**Audi**

# Technical Bulletin

**Subject: Engine Speed (RPM) Sensor (G28), Spacer Not Required**

**Number: 03-11**

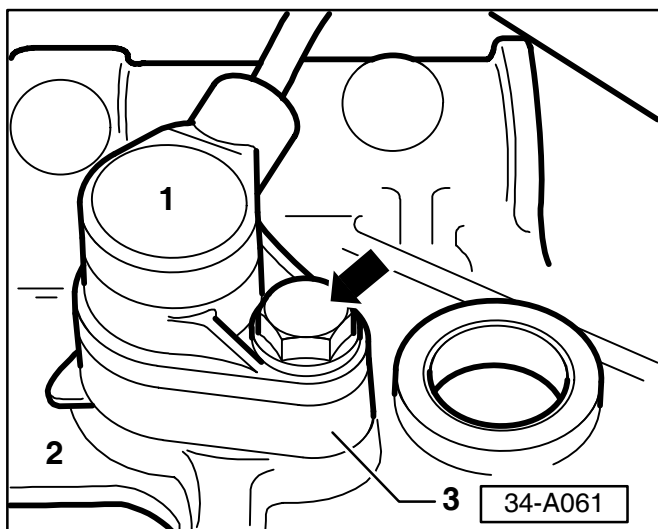
◀ For the model configurations listed below, condition may be caused by a spacer -3- installed between the Engine Speed (RPM) Sensor (G28) -1- and the transmission -2-.
